**CULTURAL RESOURCES OFFICE
PRESERVATION BOARD
REGULAR MEETING
MONDAY SEPTEMBER 28TH, 2009
1015 LOCUST ST. #1200
4:00 P.M.**

PRELIMINARY REVIEW		PG
A.	4110 BECK & 4175 CHIPPEWA PRESERVATION REVIEW DISTRICT	1
APPEALS OF STAFF DENIALS		
B.	3127 LONGFELLOW BLVD. COMPTON HILL HISTORIC DISTRICT	8
C.	3949 RUSSELL BLVD. SHAW HISTORIC DISTRICT	12
D.	2734-36 ARMAND PL. FOX PARK HISTORIC DISTRICT	17
E.	2805 McNAIR ST. BENTON PARK HISTORIC DISTRICT	21
F.	1516 MISSISSIPPI AVE. LAFAYETTE SQUARE HISTORIC DIST.	26
G.	4316, 4322 & 4328 McREE NORTH I-44 HISTORIC DISTRICT	30
NEW APPLICATION		
H.	2819 INDIANA ST. BENTON PARK HISTORIC DISTRICT	34
RESOLUTIONS FOR BOARD APPROVAL		
RESOLUTION NO. 1		
RESOLUTION NO. 2		
RESOLUTION NO. 3

Date: September 28, 2009
To: Preservation Board
From: Jan Cameron, Cultural Resources Office
Subject: Exterior alterations to one-story industrial building
Address: 4110 Beck Avenue AKA 4175 Chippewa Street **Ward: 15**
District: Board of Public Service Referral — Encroachment into Public Right-of-Way

PARTIAL ELEVATION OF BECK AVENUE FAÇADE, SHOWING PROPOSED FALSE PILASTERS AND NEW OPENINGS

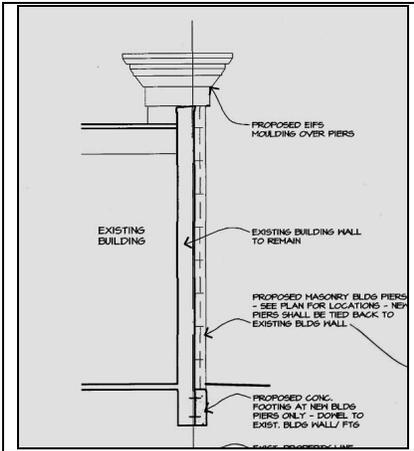
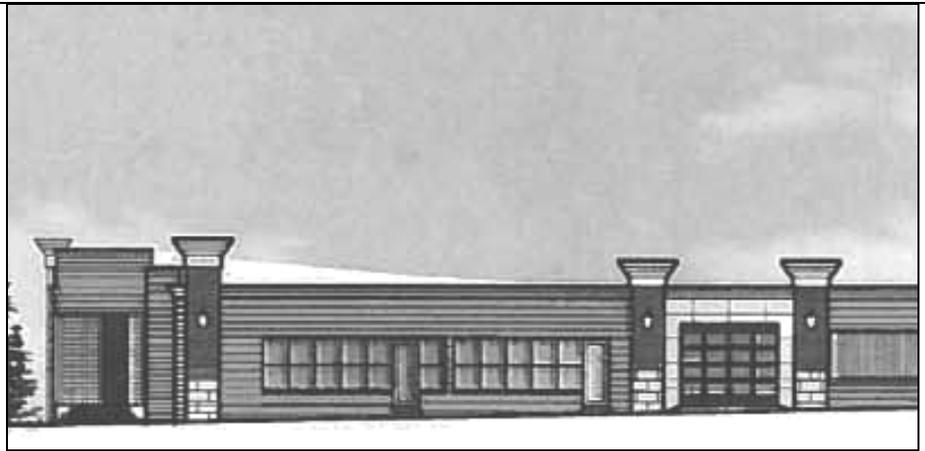
The project proposed rehabilitation of an existing one-story industrial building: installation of new openings; new windows and doors; and the addition of a number of projecting brick pilasters with overscaled capitals along the Beck and Holt street frontages.

4110 Beck is a significant example of Mid-Century Modern industrial design and the false pilasters are not compatible in scale, design or materials with the building's architectural design.

The current owners are changing the building into a storage facility. The architects of the project feel that the pilasters will break up the long horizontal elevations, which are a character-defining feature of the building's original Mid-Century Modern design. The significance of Mid-Century Modern buildings is currently being reevaluated by preservationists and architectural historians, and 4110 Beck is a noteworthy representative of that architectural style: it appears eligible to be listed in the National Register of Historic Places.

In addition to the decorative pilasters, there are proposed changes to openings on both street elevations: installation of new single-leaf doors; and replacement of glass block with ganged doublehung windows. If this building was located in a historic district or listed in the National Register of Historic Places, the Cultural Resources Office staff would object strongly to these alterations; however, as an encroachment referral from the Board of Public Service, we have no defined standards controlling the design of the building's rehabilitation. However, the intent of Ordinance 64689 clearly intends the Office and the Preservation Board to review encroachments into the public right-of-way for their impact upon the streetscape and neighborhood, and upon the design of architecturally significant structures throughout the City. The staff feels strongly that the addition of the decorative pilasters, which are proposed to be constructed of red brick and EIFS material, is an unfortunate alteration that will clearly detract from the architectural character of the building.

The Preservation Board should approve the project with the stipulation that the decorative pilasters be deleted.

3949 RUSSELL

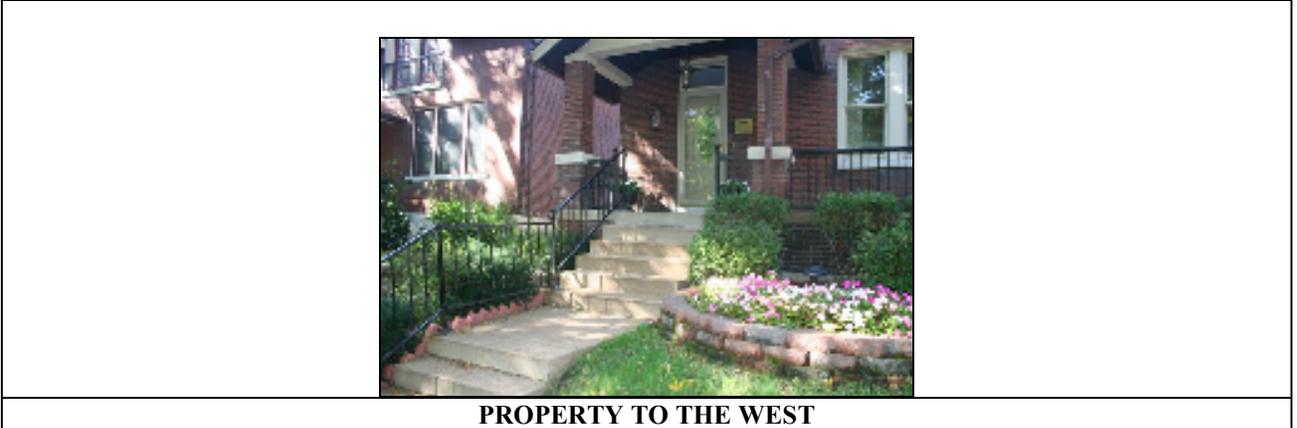
Does not comply: The addition of a plumbing pipe railing to the house does not comply with this requirement.

Does not comply: The intent of the ordinance is to prevent the installation of non-compatible elements like the plumbing pipe handrail from being used.

The Cultural Resources Office staff feels that a plumbing pipe handrail would not be compatible with the architectural vocabulary of the house. When the house was constructed, the porch steps — like many houses of the time — did not have handrails. Generally in such situations, the staff recommends a non-decorative railing to acknowledge that it is a contemporary element and not original to the house. However, installation of a railing design that is stylistically appropriate would be acceptable also. In this case, this would be a simple wrought-iron rail, perhaps with paneled newel posts, like the examples shown on this page.

The owner would prefer to retain the pipe rail due to its prevalence throughout the neighborhood. Although there are several other plumbing pipe style handrails within the Shaw Historic District, they are not an original detail. The standards state that details should remain or replaced in their original configuration.

The Cultural Resources Office staff recommends that the Preservation Board uphold the staff denial as the installed handrails are not compatible with the Shaw Historic District Standards.

DETAIL OF HANDRAIL

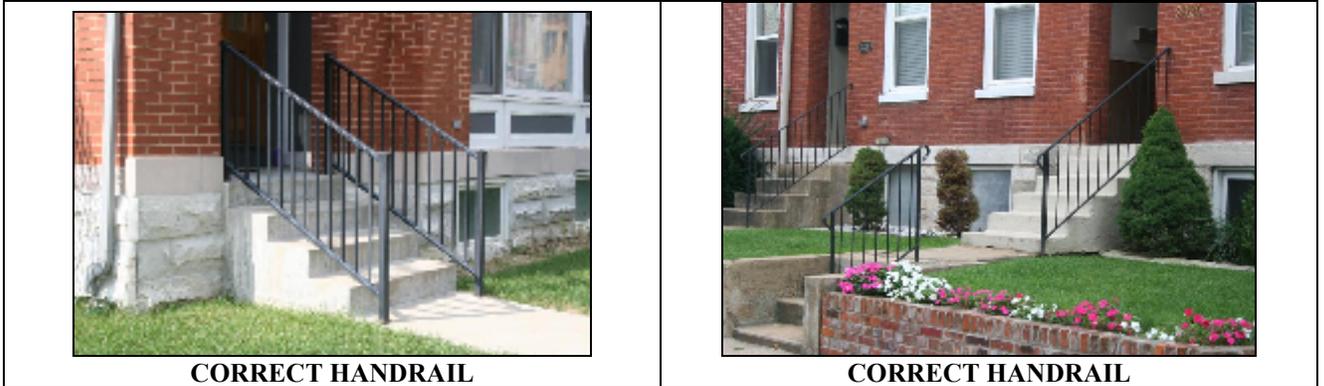
Does not comply: No Model Example was provided

Does not comply: The installed handrail is not appropriate. A typical handrail would have been a simple wrought iron variety with simple vertical balusters.

A wooden railing is not compatible with the masonry steps. Generally, wooden porches utilized wooden handrails. When wood is used in conjunction with a masonry porch, it tends to rot quickly. When the house was constructed, the porch steps — like many houses of the time — did not have handrails. Generally in such situations, the staff recommends a non-decorative railing to acknowledge that it is a contemporary element and not original to the house. However, installation of a railing design that is stylistically appropriate would be acceptable also. In this case, this would be a simple wrought-iron rail, perhaps with paneled newel posts, like the examples shown on this page.

The Cultural Resources Office staff recommends that the Preservation Board uphold the staff denial as the installed handrails are not compatible with the Benton Park Historic District Standards.

DETAIL

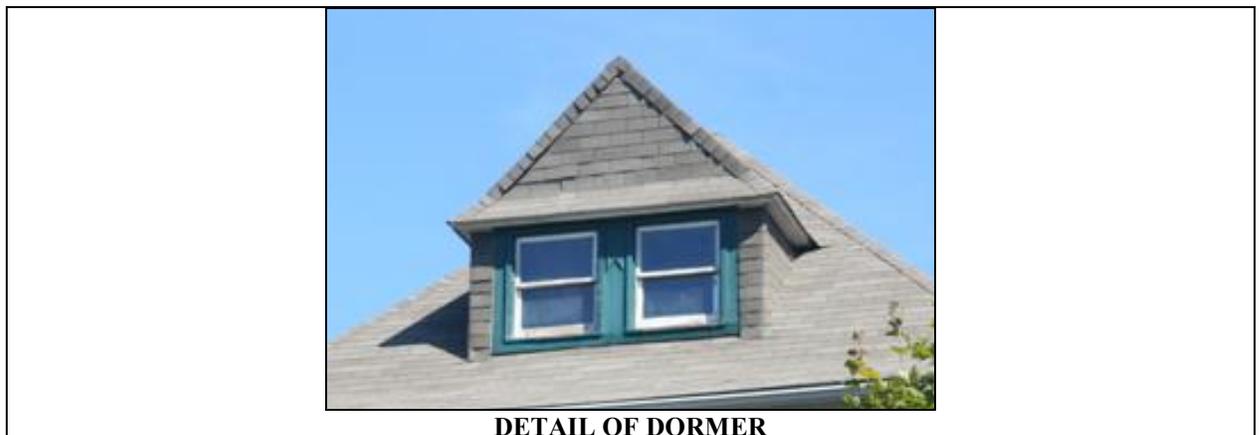
Does Not Comply: The proposed casement windows will not have the same appearance as the original double-hung windows. The applicant is proposing to install a false horizontal muntin, which will present a flat appearance and not provide the depth of a double-hung sash window.

Even though the proposed windows are wood, the casements windows will not replicate the appearance of the double-hung windows. The owners have not provided any evidence that installing the proper windows would cause financial hardship. The contractor stated that the only sash window that would work was too expensive.

The Cultural Resources Office recommends that the Preservation Board uphold the staff denial of the application and to not issue a variance as the windows do not meet the Lafayette Square Historic District Standards.

DETAIL OF WINDOWS TO BE REPLACED

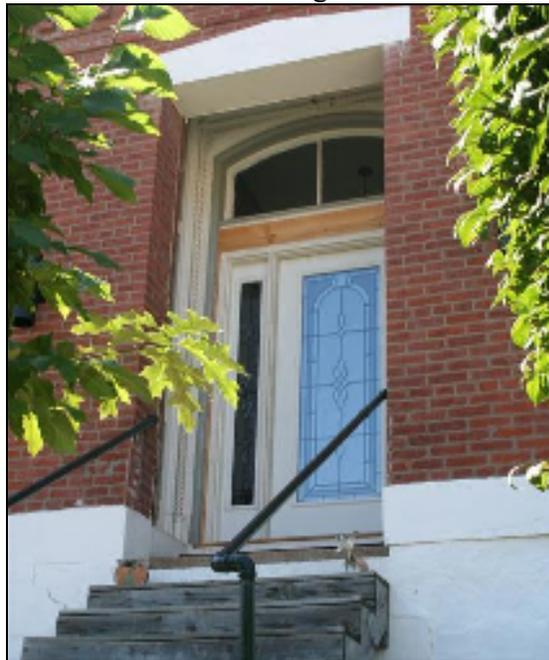
Does not comply: The new door does not replicate the original. Also, a model example was not provided.

The original door would not have had glass and be comprised of four or six recessed panels. The contemporary door and side light are too elaborate and not appropriate for the simple Federal style building. The door is also too small for the opening and the larger transom bar is out of scale with the original fabric. Since the original door was not in place when the owner installed the current door, we would have asked for a full-light door that fit the entire opening.

The Cultural Resources Office staff recommends that the Preservation Board uphold the staff denial as the installed door and sidelight are clearly not compatible with the Benton Park Historic District Standards.
